**Vogtle Electric Generating Plant – Units 1 and 2
Response to NRC Request for Additional Information
Associated with Flooding Re-evaluation**

**Vogtle Electric Generating Plant – Units 1 and 2
Response to NRC Request for Additional Information
Associated with Flooding Reevaluation**

RAI Responses for the Vogtle Electric Generating Plant – Units 1 and 2

Figure 1 – Definition sketch for broad-crested weir equation (Reference 1)

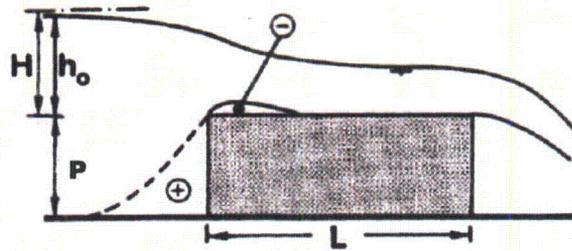
The licensee is requested to provide (1) a discussion of roof drainage features (e.g., scuppers, gutter outlets, etc.) for plant buildings, and how runoff from these drainage features are incorporated into the local intense precipitation flood analyses; (2) a detailed description of the methods and site data used to develop and apply the Vehicle Barrier System (VBS) stage-volume relationship, the VBS broad-crested weir equations, and the VBS rating curves related to the local intense precipitation flood analysis; and (3) an electronic versions of the spreadsheet used to construct the VBS rating curves described in Calculation Package No. X2CA77.

- b. The elevation of the VBS is not constant around the perimeter of the power block area. To determine the stage-discharge relationship, the VBS is divided into many segments of constant elevation. Additionally, there are two rows of the VBS referred to as inside and outside rows. Discharge over the VBS is treated as a case of broad-crested weir discharge, as discussed in the IAHR Hydraulic Structures Design Manual (Reference 1). Discharge per unit length of a broad-crested weir is given in the reference manual as:

Where H is the energy head on the weir (i.e. elevation plus velocity head), and C_d is a discharge coefficient determined empirically as a function of head and L representing the flow length over the weir crest, (see Figure 1), according to the following empirical relation (Reference 1):
